Amendments to the Drawings

Applicant: Daniel J. Durda
Serial No.: New US Patent Application
Filed: April 15, 2004
For: AERATOR
Docket: 1015.1126101
Sheet 1 of 3

Figure 1

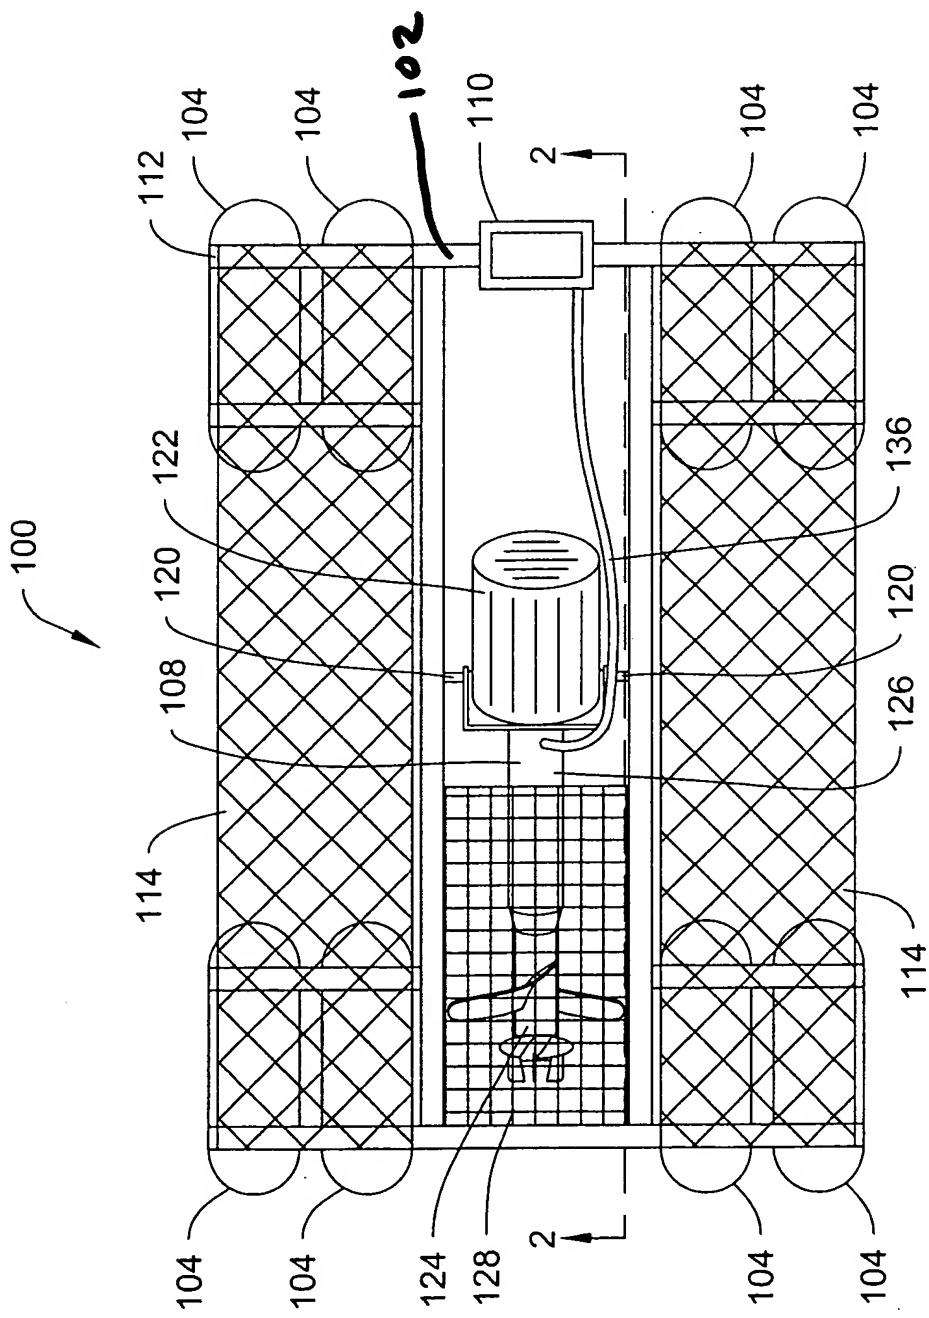
In paragraph 3 of the Office Action, the Examiner objected to the drawings under 37 C.F.R. § 1.84(p)(5) for not including reference signs “102” and “116” mentioned in the Specification. In addition, in paragraph 4 of the Office Action, the Examiner further

objected to the drawings under 37 C.F.R. § 1.84(p)(4) stating that reference character “136” has been used to designate both a flexible hose in Figures 1 and 2 and the primary propeller in Figures 2 and 3. According to the Examiner, corrected drawing sheets in compliance with 37 C.F.R. § 1.121(d) are required in reply to the Office Action in order to avoid abandonment of the application.

In response to these objections, Applicant has submitted herewith three corrected drawing sheets along with a marked-up copy of the old drawings indicating those changes made. In particular, Applicant has amended the drawings to add reference numbers 102 and 116 in Figures 1-2. Moreover, Applicant has changed reference number “136” used to designate the primary propeller in the drawings and the specification to now read “137”. Applicant respectfully asserts that these drawing amendments overcome the Examiner’s objections to the drawings.
